File Note

Project Title	HIF Banwell Bypass and Highways Improvements Project
Document Title	Wider Network Mitigation - Additional Speed Survey Data
Document Reference	BNWLBP-ARP-HGN-XXXX-TN-CH-000001
Prepared by	Rob Henley
Status	S8 FOR PLANNING APPLICATION
Revision Date	P02 13/12/22

1.1.4 This Technical Note summarises the results of the additional speed surveys undertaken and sets out the amended extents to the speed limit proposals as shown on updated Wider Network Mitigation – General Arrangement Drawings.

Figure 7 Speed survey results in Winscombe

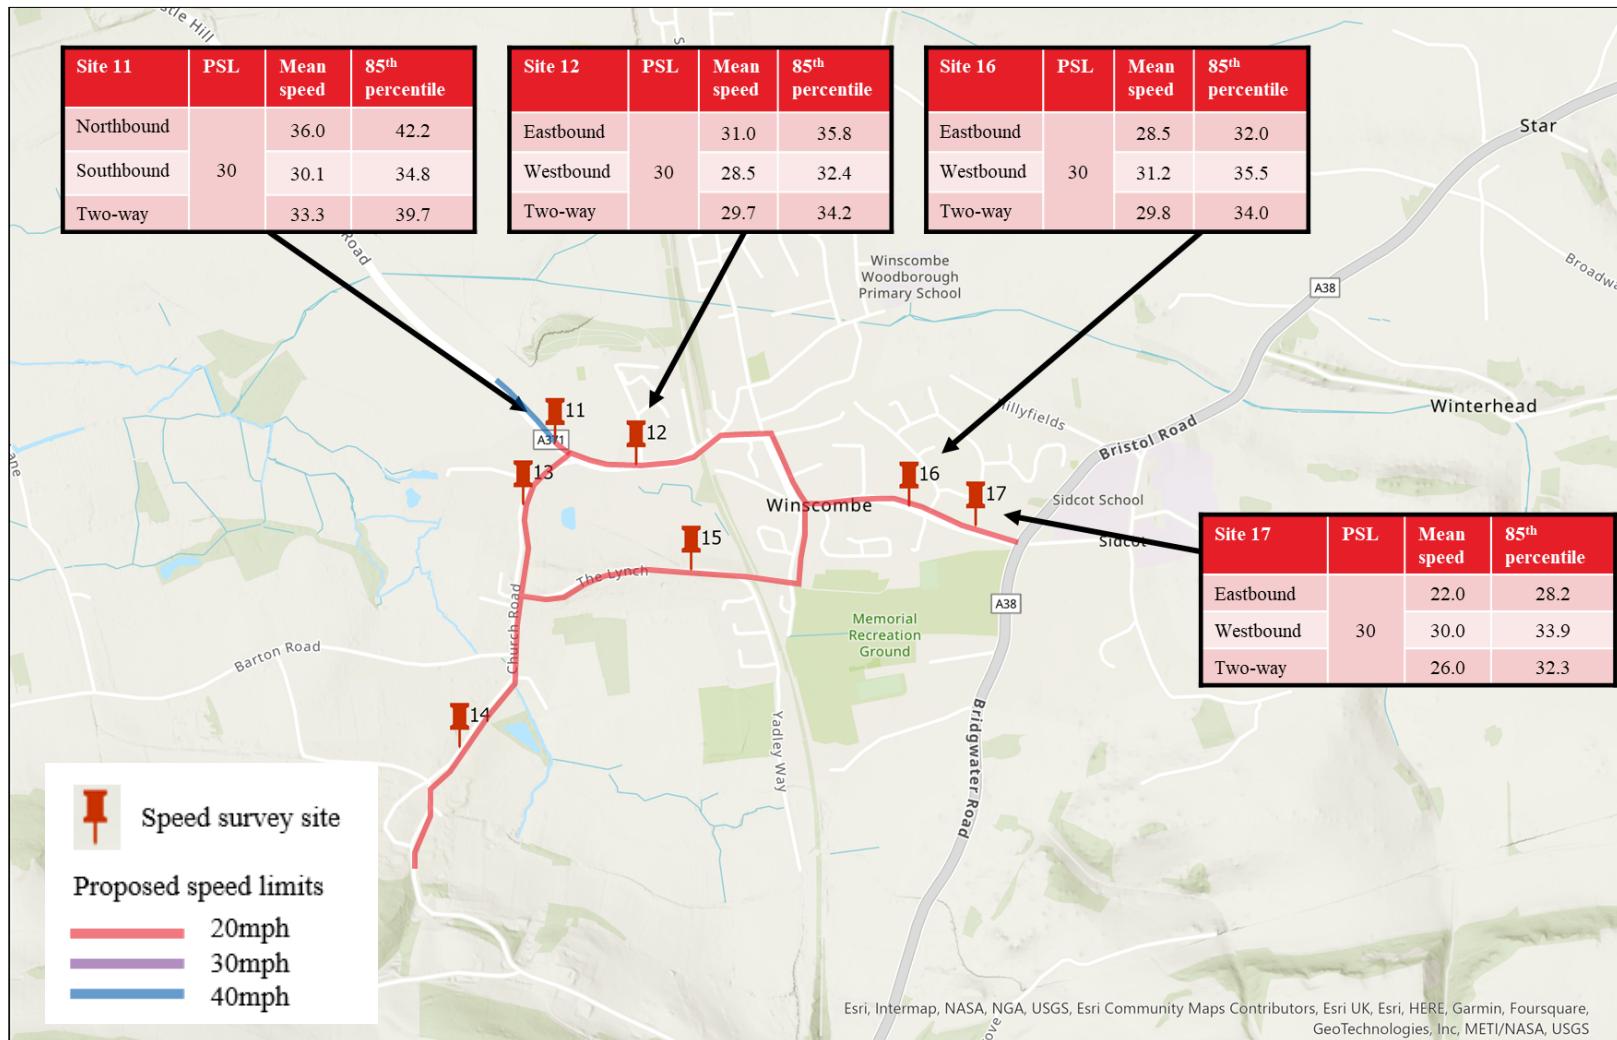
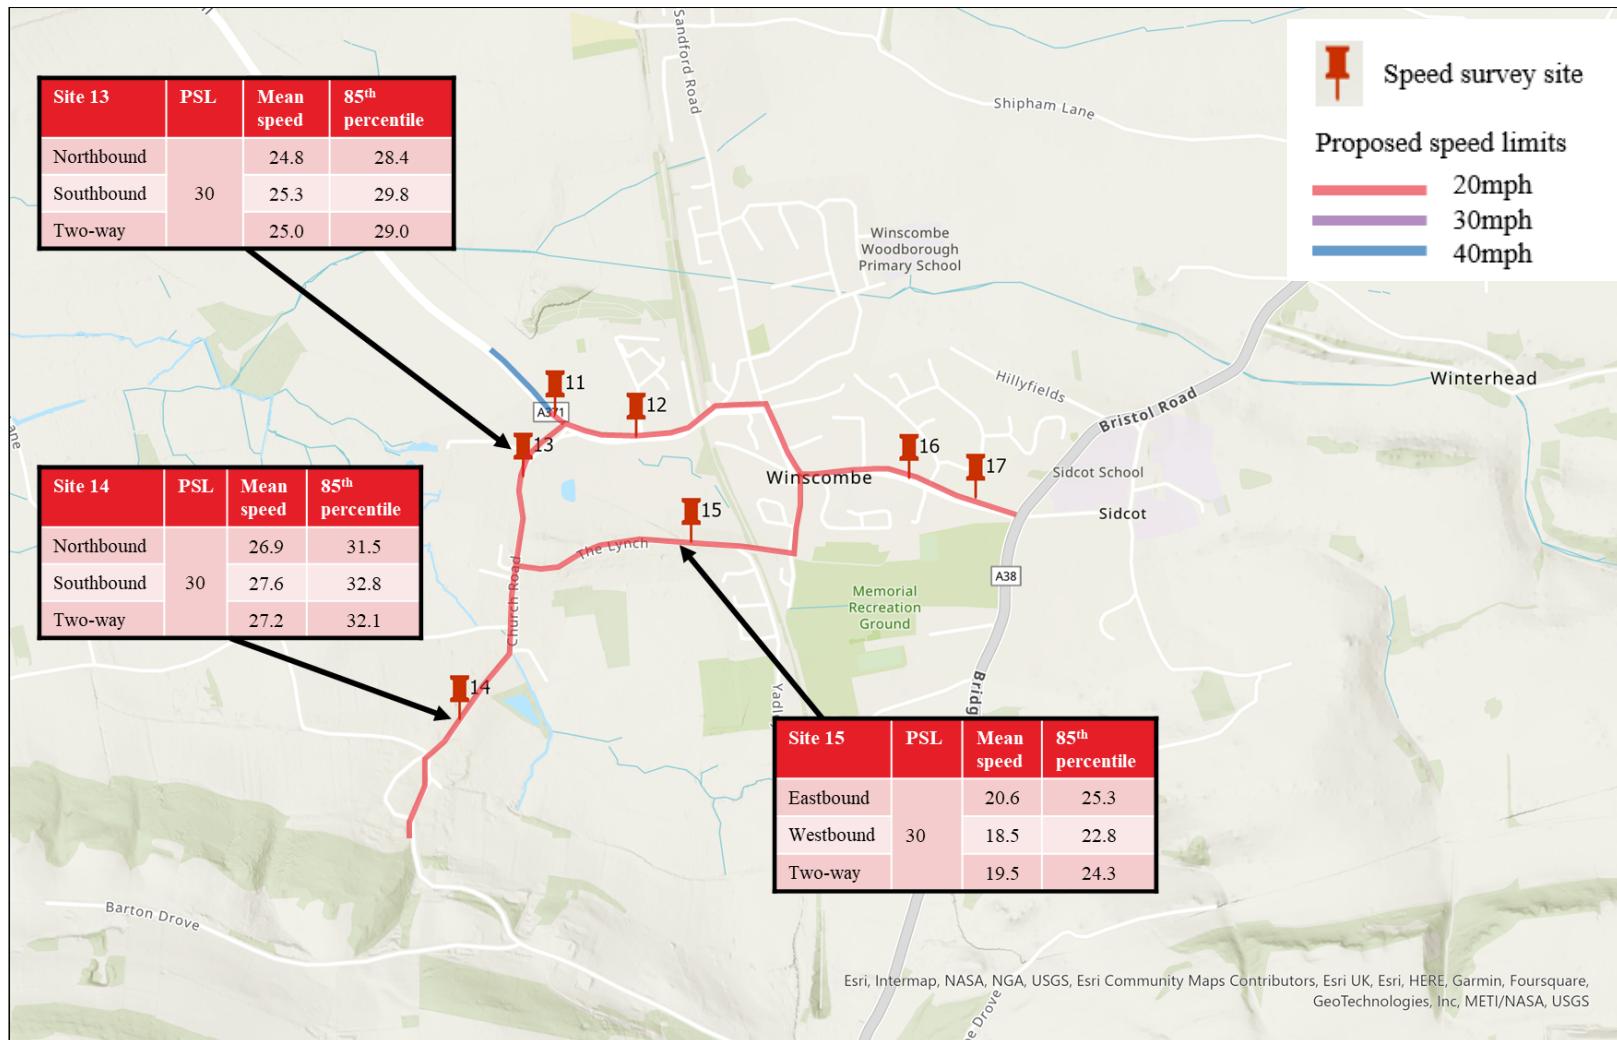
5.1.1 This section details the traffic speed survey results and proposed speed limit changes in Winscombe. The survey results have informed and provided justification for the proposed speed limit changes. The following roads are proposed for speed limit reductions to 20mph:

1. Banwell Road (reduction from NSL to 40mph just outside Winscombe and 30mph to 20mph reduction at entrance to Winscombe);
2. The Lynch;
3. Church Road leading to Winscombe Hill;
4. Woodborough Road; and
5. Sidcot Lane.

5.1.2 A 40mph buffer is also proposed where the speed limit transitions from national speed limit to 20mph on the A371 Banwell Road.

5.1.4 The speed survey on Banwell Road was undertaken at the transition point from 30mph to national speed limit, and the results indicate that northbound mean vehicle speeds exceed the current speed limit where vehicles are accelerating towards the higher speed limit. Southbound, mean vehicle speeds are very marginally in excess of the posted speed limit, as vehicles decelerate when entering the 30mph.

5.1.5 The speed survey along Woodborough Road (survey site 12) indicates speeds are lower in both direction towards the centre of the village. Westbound mean speeds are lower than the current speed limit of 30mph whereas in the eastbound direction the mean vehicle speeds are slightly higher than 30mph. Overall in both directions the mean speed of vehicles is at the speed limit.

5.1.6 The speed surveys on Sidcot Road (survey sites 16 and 17) indicate

that mean vehicle speeds eastbound are lower than the current speed limit of 30mph whereas in the westbound direction the mean vehicle speeds either meet or slightly exceed the speed limit. Eastbound speeds approaching the A38 are much lower, presumably due to the proximity to the junction.

5.1.7 In order to encourage compliance and improve safety for all users, the proposals for a reduced 20mph speed limit on this section of the A371 are accompanied by the following infrastructure changes:

1. Gateways into Winscombe;
2. Carriageway narrowing with proposed dragon's teeth marking to give effect of lane narrowing to slow traffic;
3. Speed limit reduction north of Winscombe from NSL to 40mph to reduce speeds of vehicles approaching 20mph zone;
4. Upgrade to the existing uncontrolled crossing (west of Knapps Drive) to a zebra crossing with raised crossing;
5. New zebra crossing (west of the junction with the Chestnuts) with raised crossing;
6. New zebra crossing (east of the Strawberry Line) with raised crossing;
7. Hatched road markings to narrow road to 6m, reducing traffic speeds; and
8. Additional raised table traffic calming features between The Chestnuts and the A38.

5.1.9 The speed survey along The Lynch (survey site 15) indicates that mean vehicle speeds in both directions are lower than the current speed limit of 30mph and lower than 24mph in both directions. Compliance with the proposed 20mph reduced speed limit is therefore expected with a lighter-touch approach, based on traffic signs and lining only.

5.1.11 The speed surveys along Church Road (survey sites 13 and 14) indicates that mean vehicle speeds in both directions are lower than limit of 30mph. Since most drivers along this road are already moderating their speed to drive slower than 30 mph plans to change the speed limit to 20 mph should require fewer infrastructure interventions. To encourage compliance and improve safety for all users the proposals for a 20mph speed limit are accompanied by the following infrastructure:

1. Build-outs requiring vehicles to give way through narrowings;
2. Gateway feature on Barton Road; and
3. Updating of existing and new “SLOW” road markings.
